UNITED STATES PATENT AND TRADEMARK OFFICE

Office Action Summary

This is an office action for serial number 10/712,300, entitled Bracket For Supporting Articles on a Wall, filed on November 14, 2003.

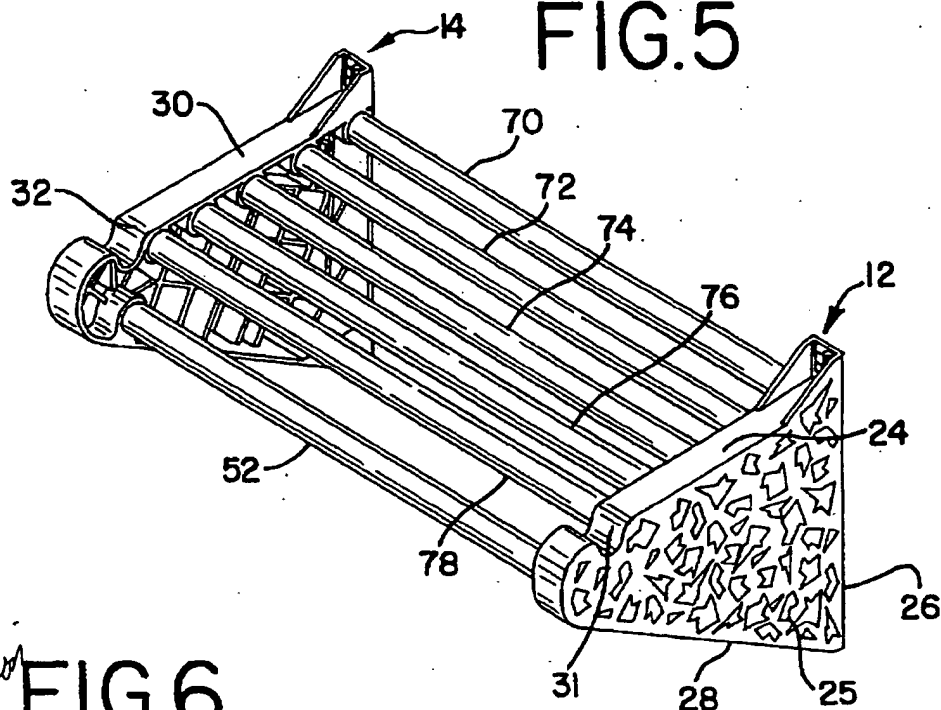
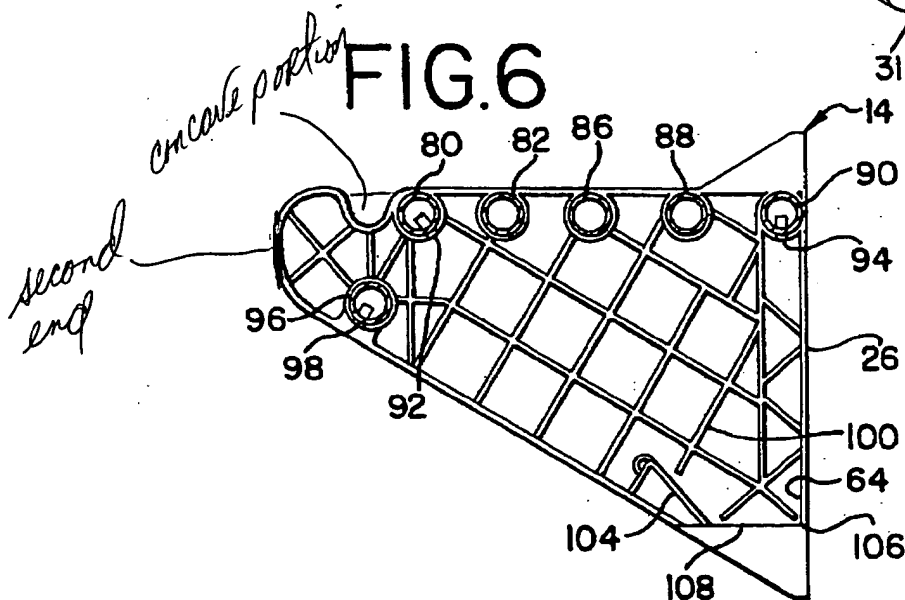
Marontate discloses all of the limitations of the claimed invention except for the bottom wall second portion. Whitehead teaches that it is known to have a bottom portion including a second portion (see attached figure) at a second end (see attached figure) so as to define a concave portion (31) of the bottom wall. It would have been obvious to one having ordinary skill in the art to have modified Marontate to have included the second portion and a second end wall as taught by Whitehead for the purpose of operating as a hook for placement of various sporting items. The modification of Marontate in view of Whitehead would result in the bottom wall having a second end wall being spaced from the top wall by a greater distance than an adjacent end of the first portion of the bottom wall (see figure 6 of Larson, similar to what Marontate combined with Whitehead would look like but without the detent 31 of Whitehead).
